SERVICE BULLETIN

APPLICABILITY: 2014MY Forester

NUMBER: 09-55-13

SUBJECT: Fuel Tank Insulation Pad / Fuel Delivery Tube Changes

COUNTERMEASURE IN PRODUCTION

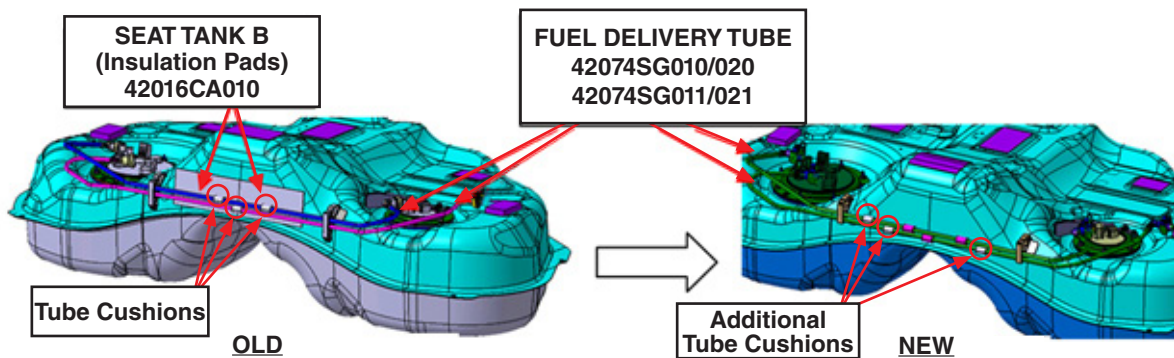
This Bulletin informs of changes to both the padding on the fuel tank assembly and the cushions found on the fuel delivery tubing connecting the main fuel pump assembly to the sub-level unit (transfer pump).

The new parts were incorporated into production starting with VIN E*412069.
